STAFF RECOMMENDATION

NCPC File No. 6666

LAFAYETTE BUILDING
BUILDING MODERNIZATION & PERIMETER SECURITY
811 Vermont Avenue, NW
Washington, DC

April 27, 2006

Rooftop Equipment

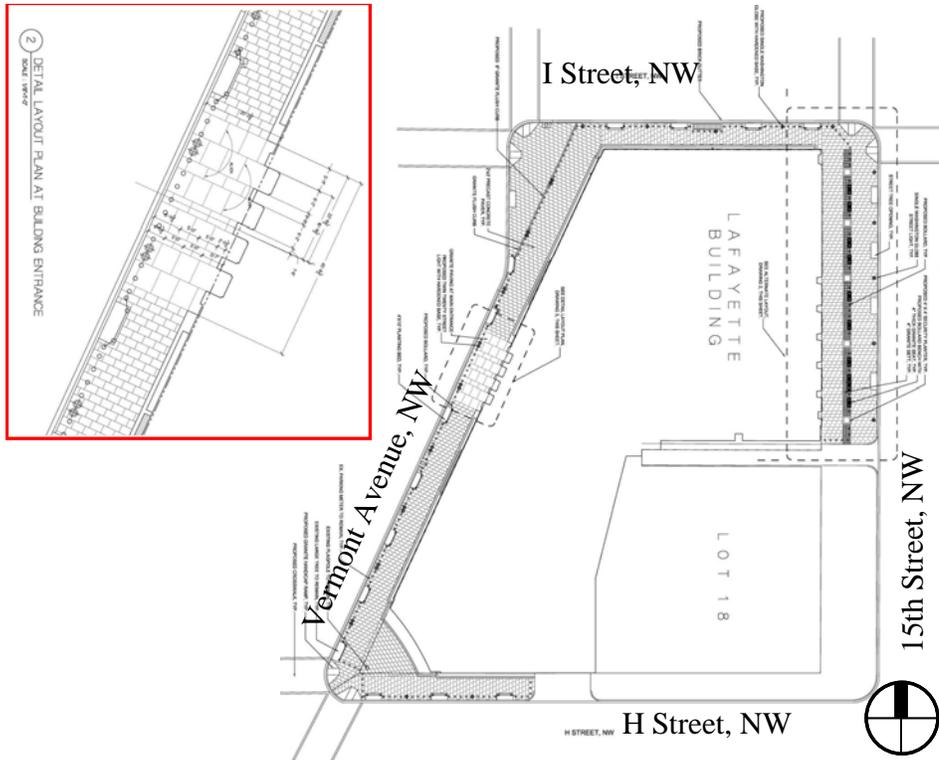
At a consultation in November, 2005, GSA provided images for viewshed analysis showing how the new and relocated rooftop equipment would be seen from the ground, but only from points east, north and west. In that analysis, the applicant shows that the 17-foot high cooling tower would be visible 275 feet from the building on the east, 15th Street side.

In order to verify that the rooftop equipment would not have an adverse effect on historic views and vistas, staff recommends that the applicant include with the final submission materials simulations of views from points southwest, including Lafayette Park and the base of the Washington Monument, showing the impact of changes to the rooftop equipment.

Perimeter Security Proposed Along Vermont Avenue, NW

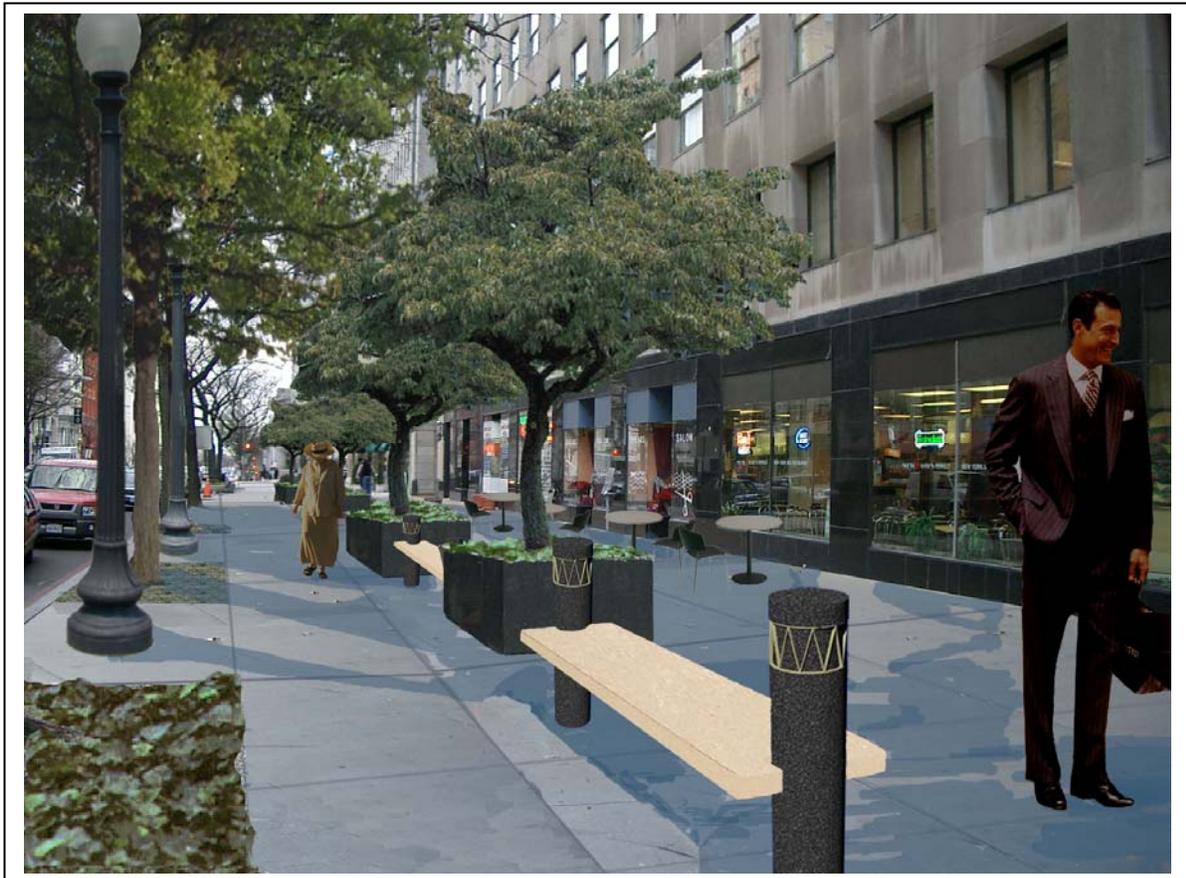
Vermont Avenue: For diagonal avenues such as Vermont Avenue, the design framework recommends a tree enclosure fence wall at the back of the planting strip next to the sidewalk, and a combination of benches, bollards and other hardened street furniture between the fence wall segments. The proposal is generally consistent with the

recommended location of security elements, but not the streetscape simulation provided shows only bollards, not the combination of elements recommended in the UDSP. Without the use of benches and fence walls, the palette of urban tools used remains limited.

More importantly, the greater context of the area has not been addressed. A sister federal building, also occupied by the Department of Veterans Affairs, (VA), faces the Lafayette Building from the west side of Vermont Avenue. The UDSP clearly anticipates a unified design for both sides of Vermont Avenue between Lafayette and McPherson Squares. The submission proposes solution for perimeter security for the Lafayette Building in isolation from the VA Building. Staff **recommends** that the applicant develop a variety of hardened streetscape elements along Vermont Avenue as proposed for this area in the National Capital Urban Design and Security Plan, and coordinate the design for both sides of Vermont Avenue between Lafayette and McPherson Squares.

- Staff recommends that the applicant expand the palette of security elements used along Vermont Avenue in accordance with NCPC policies against the repetitive use of single elements.

Access Points

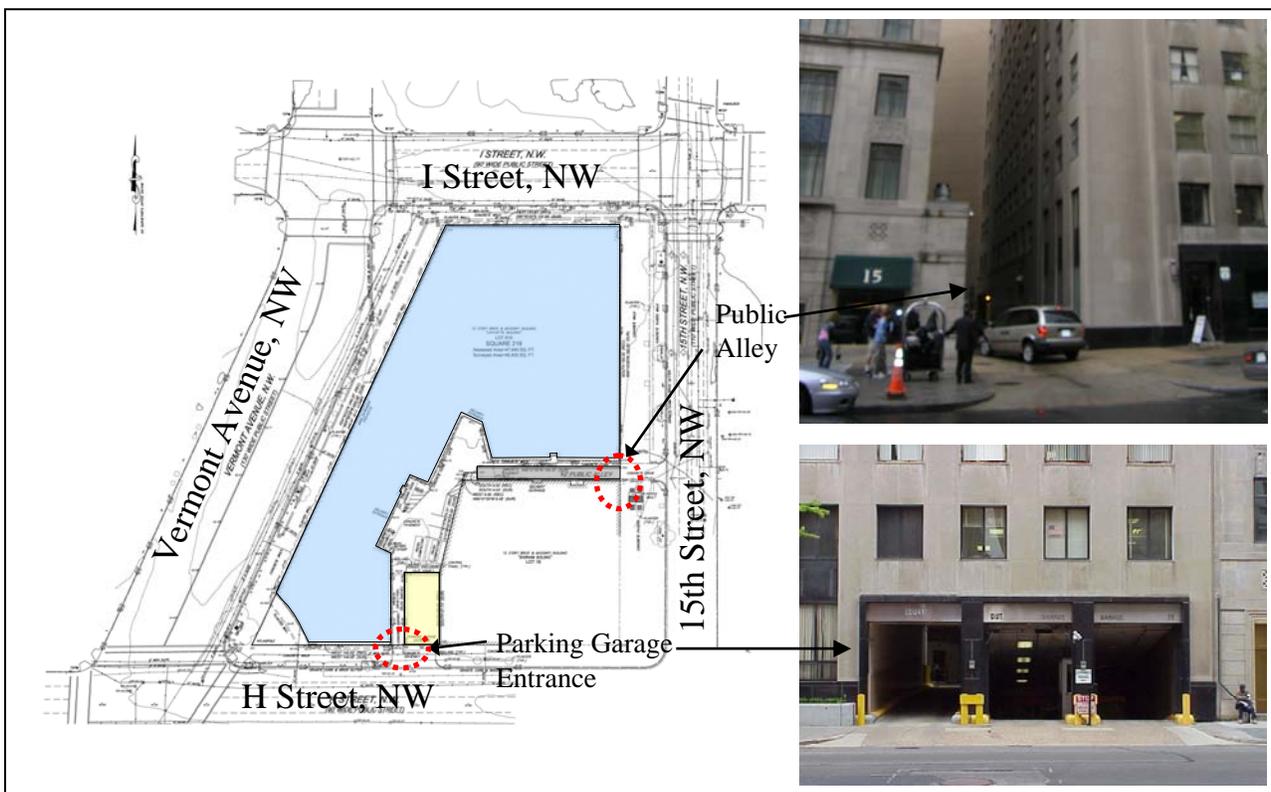
Drawings show uncontrolled access points beyond the proposed barrier line, leaving these areas vulnerable. Unprotected access points include the public alley intersecting 15th Street, with use shared with the adjacent Shoreham Building, and the private drive-through for the Lafayette Building, with entrance from H Street. In addition, the ramp leading to underground parking has its entrance from H Street. Staff **recommends** coordination with the adjacent property owner to develop design strategies for providing perimeter security at the public alley from 15th Street. Staff **recommends** that the applicant consult further with staff from the District Department of Transportation (DDOT) and the DC State Historic Preservation Office (SHPO) as well as from NCPC in developing perimeter security that would minimize encroachment of public space and that would minimize its adverse effect on the historic L’Enfant streetscape.

Perimeter Security Shown Along 15th Street, NW

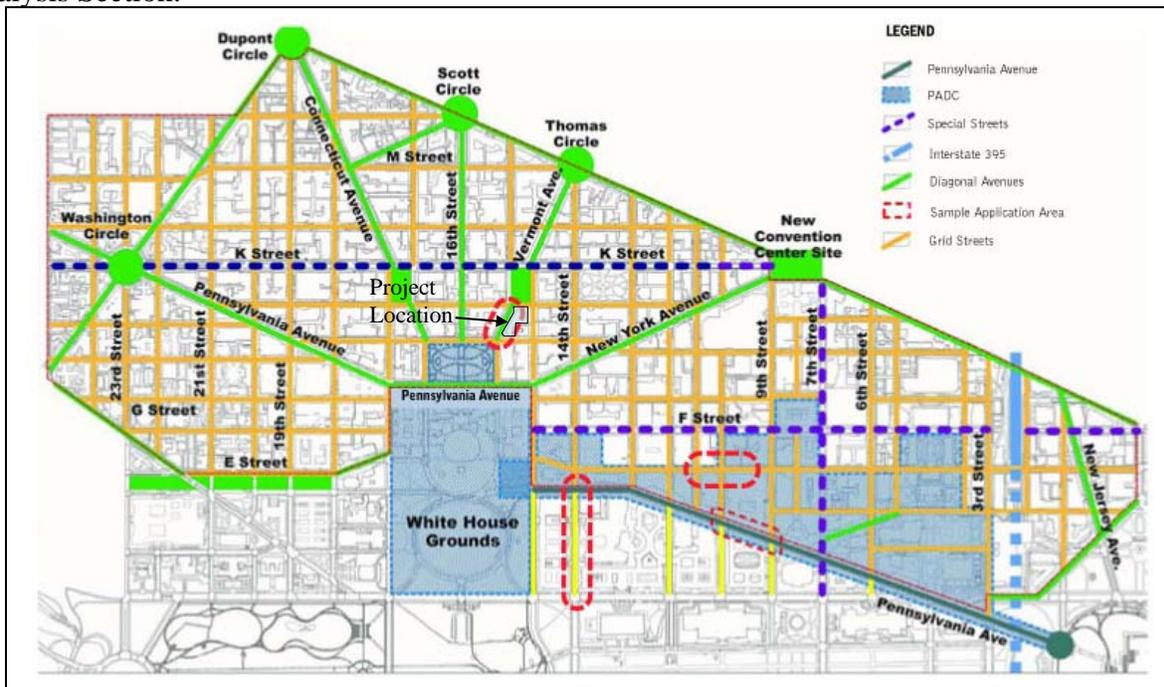
15th Street: The design framework for grid streets in the Downtown Contextual Area recommends hardened components of the Downtown Business Improvement District's (BID) streetscape elements, including street light standards, tree fence enclosures, benches, bicycle racks, trash and newspaper vending containers, and the introduction of bollards. The current proposal is in general conformance with this recommendation with regard to H and I Streets, but varies in proposing a combination of planters, bollards and benches at in the middle of the sidewalk along 15th Street instead of at the curb. Staff is generally supportive of the proposed use of streetscape elements to frame the space for seating to serve ground floor retail, but is concerned that the proposed design and spacing of these elements will obstruct pedestrian access and reduce the viability of those retail locations. Staff recommends preserving the building's historic retail uses along 15th Street, and coordinating with retail tenants and the Downtown Business Improvement District to ensure that adjacent security elements do not impede the area's commerce and vitality. Photo simulations show two alternative placements of bollard benches.
